RE: Master Drainage Report for Westpoint 40
Drainage Master Plan
Stamp Date: 8/25/17
Hydrology File: K09D041

Based upon the information provided in your submittal received 8/25/17, the Drainage Master Plan **is not** approved for Work Order. The following comments need to be addressed for approval of the above referenced project:

MASTER DRAINAGE REPORT FOR WESTPOINT 40 (AVALON SUBDIVISION UNIT 5)

**EXHIBIT 2 – EXISTING CONDITIONS
DRAINAGE MAP**

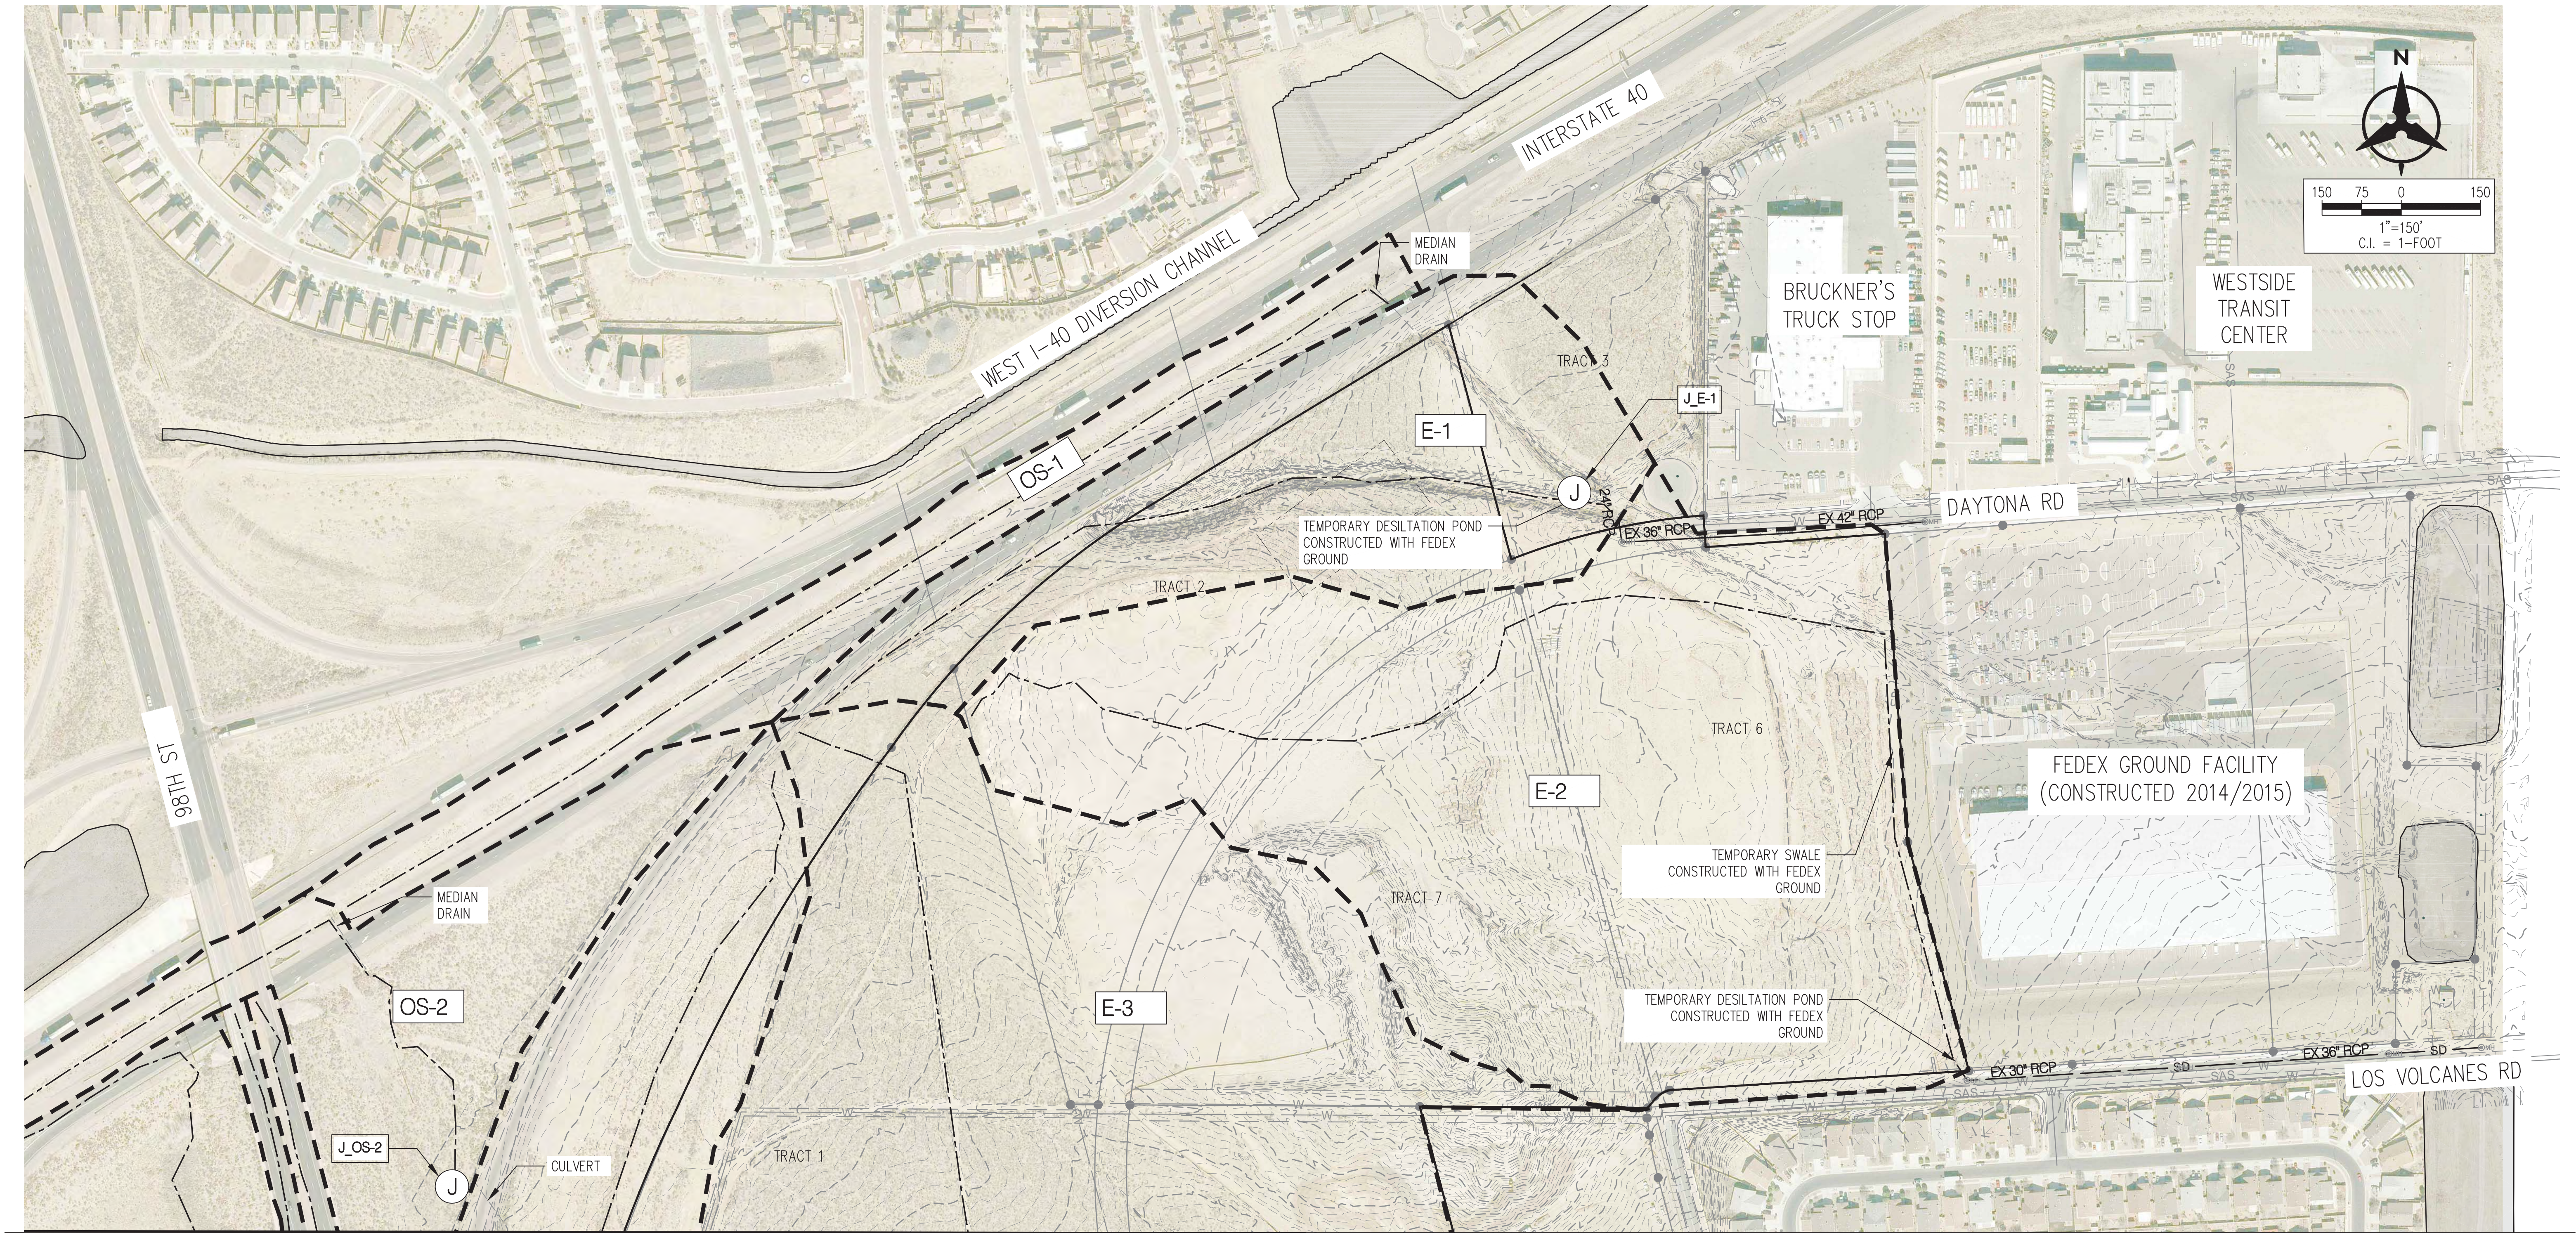
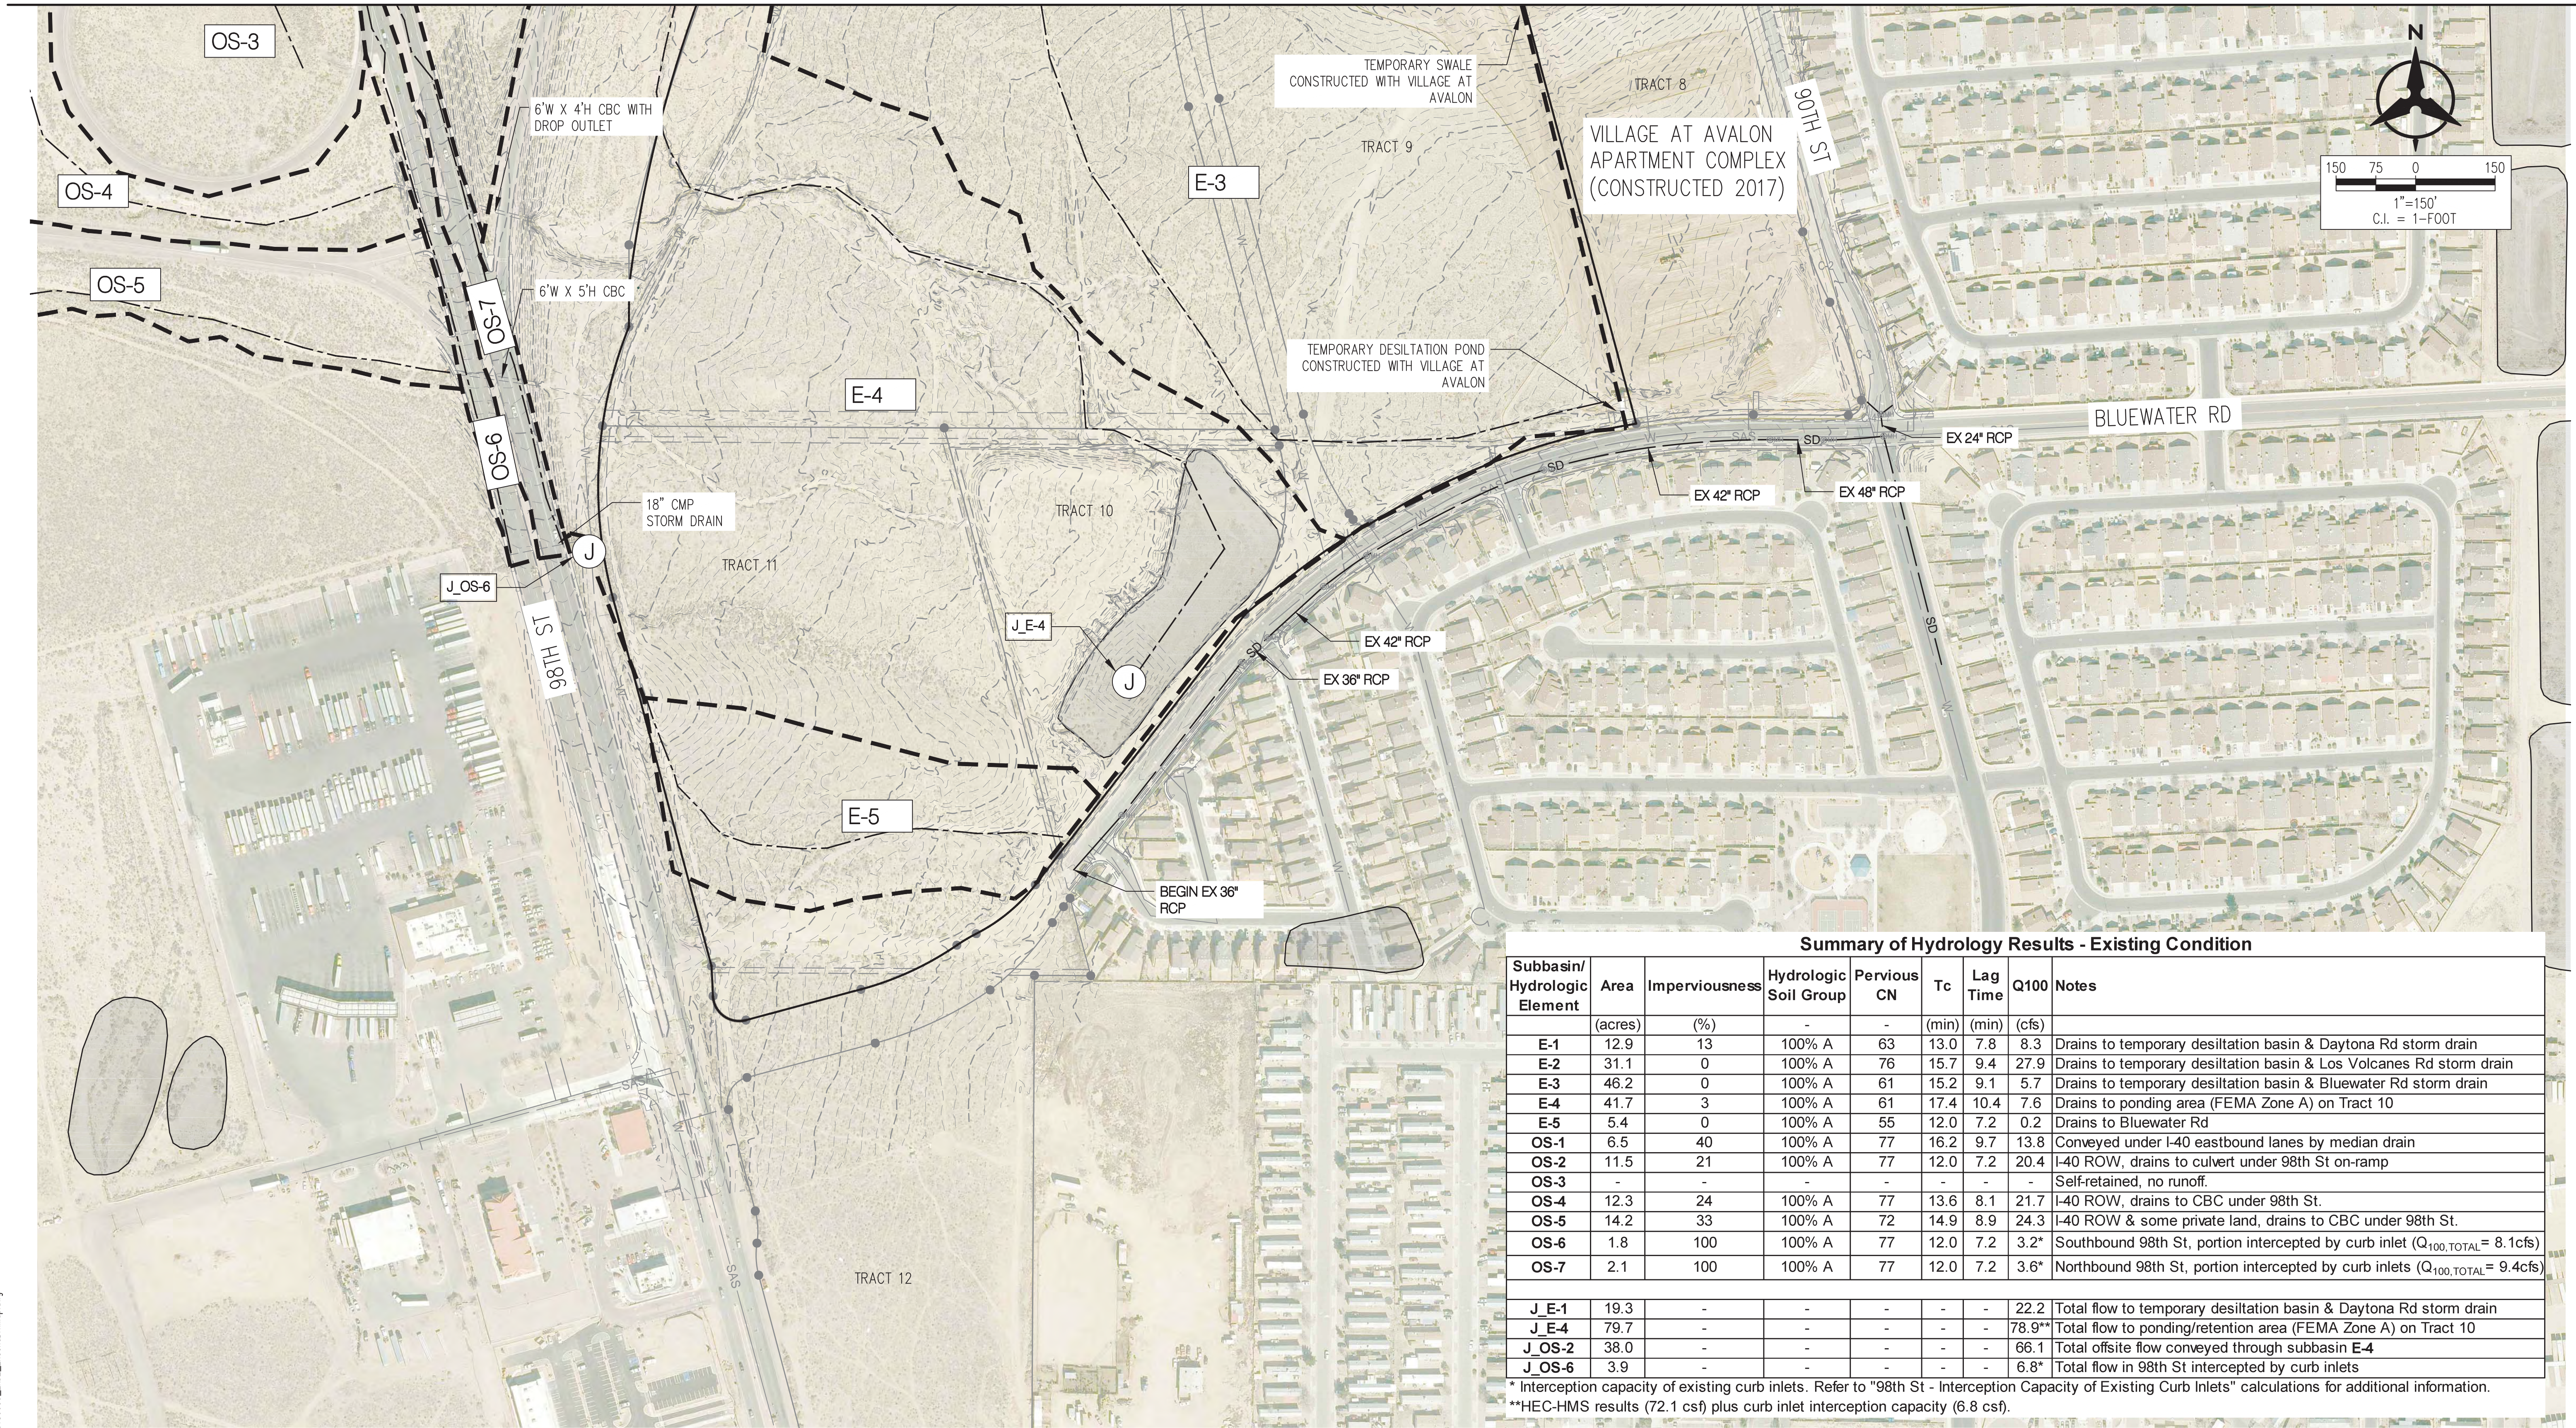
1. On your existing model, Point J_OS6 needs to be routed through a reach to J_E-4. This existing drainage channel can be seen on the aerial.
